Victoria Quarter

**A Scheme That
Designs-in Problems**

Save New Barnet
Response to Planning Application
21/3676/FUL
September 2021

Blocks E, F1, 2 &3, F4, and G - Facing the Railway Embankment and Spine Road –
Yellow line indicates non opening windows.

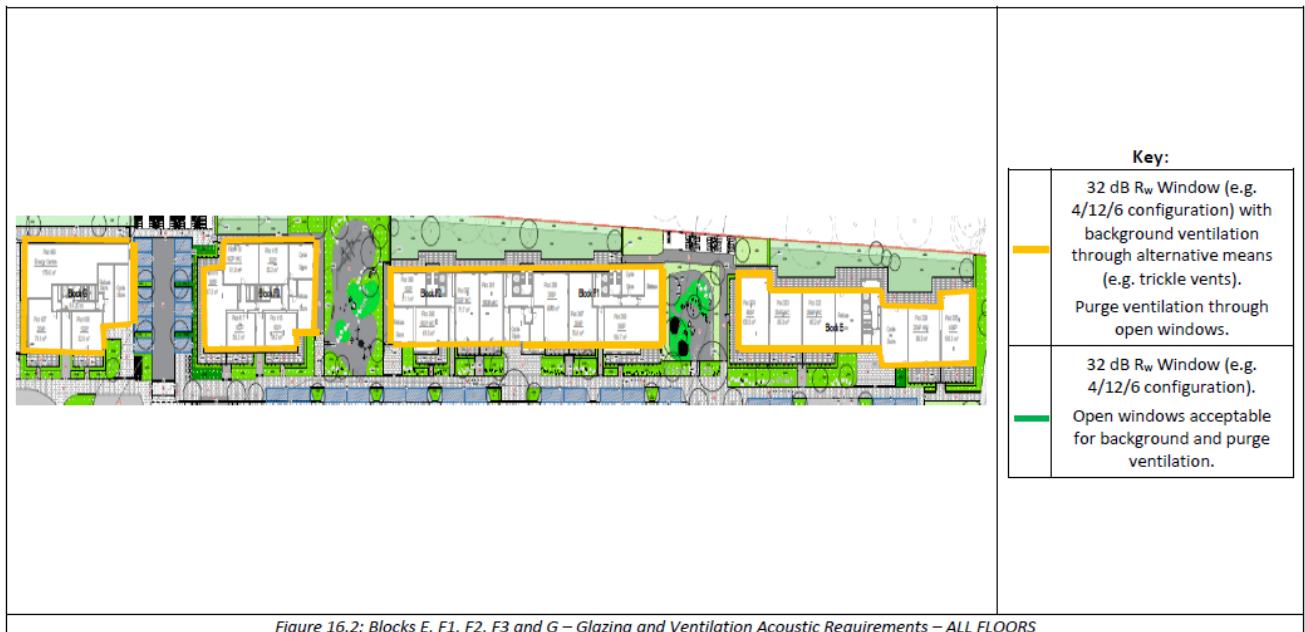
“For the units facing the Railway and Victoria Road the acoustic assessments have identified that windows along these elevation must remain closed during day time and night time and therefore cannot be relied upon to provide purge ventilation for mitigating excess heat”.

The design of the scheme has created such serious noise issues that hundreds of the flats will be required to have non opening windows. This could have been overcome in all of the blocks, other than those facing Victoria Road, with better design, something the Save New Barnet campaign team shared with the applicant and their architects. As such, this scheme is in breach of London Plan Policy D14.

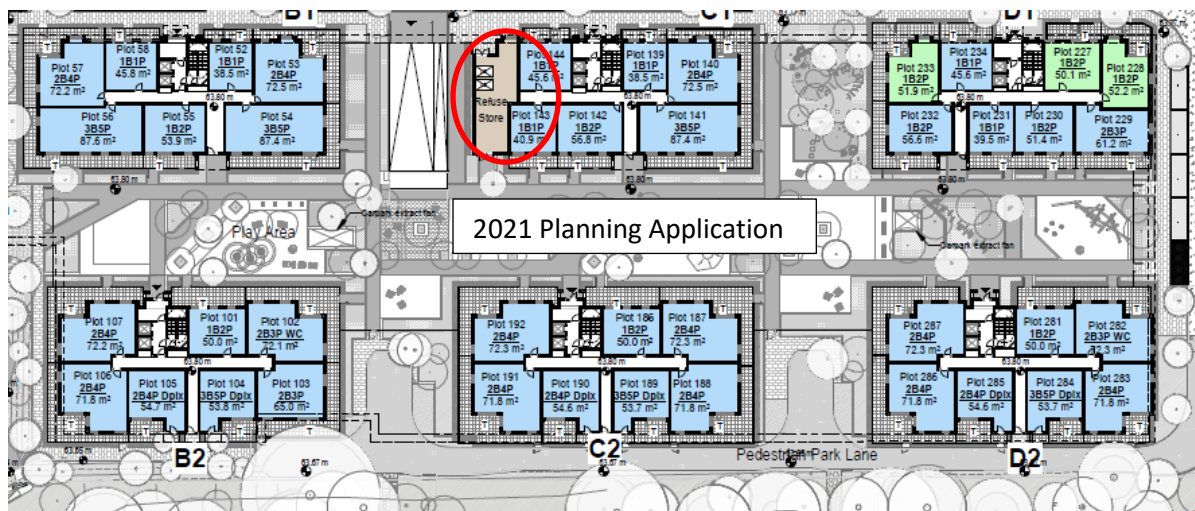
The development is forecast to generate 181,628 litres of waste each week. This will require a total of 170 commercial size 1,100 litre bins and 25 domestic size 240 litres bins for food waste. In the blocks adjacent to the railway embankment, the Gateway site and Block A, they will all have surface level bin stores.

In the 2020 scheme, Blocks B1, B2, C1, C2, D1 & D2 all had surface level refuse stores in close proximity to refuse collection points.

Basement Level Bin Stores:

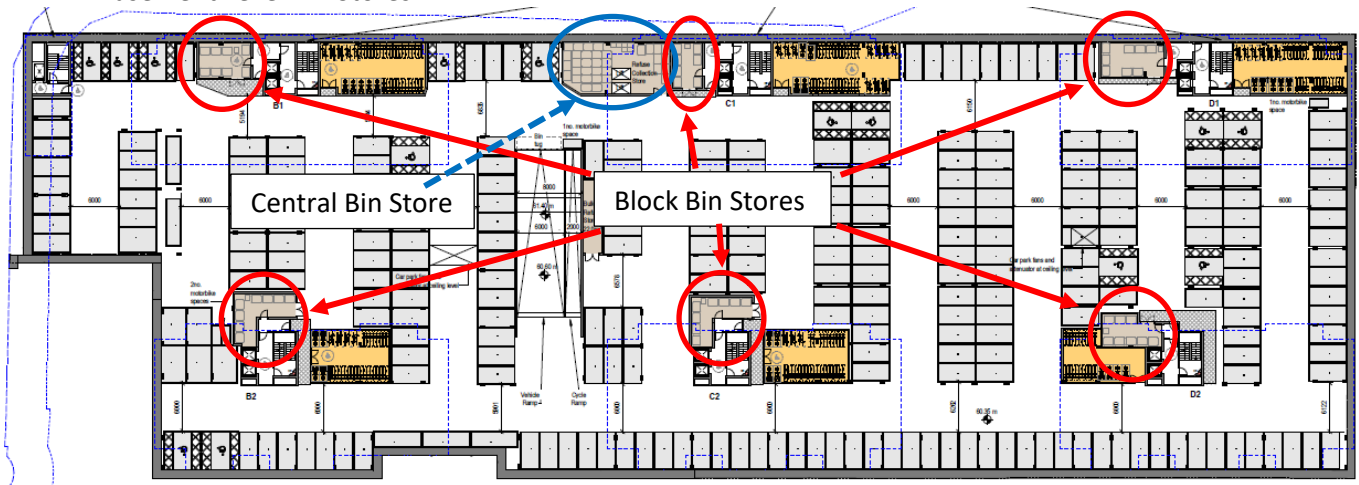
The consequence of this major design change is that residents of these 6 blocks will now have to go to the basement to drop off their rubbish, something which may be off putting to some tenants. However, these basement bins stores only have capacity for three days storage so in

addition there is a further large bin store which will hold the additional bins. This is shown on the chart below.

As a result, the building management team will have to regularly monitor the bins within the individual core bin stores (ringed in red) and once the bins get full, they will have to replace these with an empty bin from the central basement bin store (ringed in blue). In order to transfer bins from the core bin stores, to the central bin store, the building management team will use electric tugs.
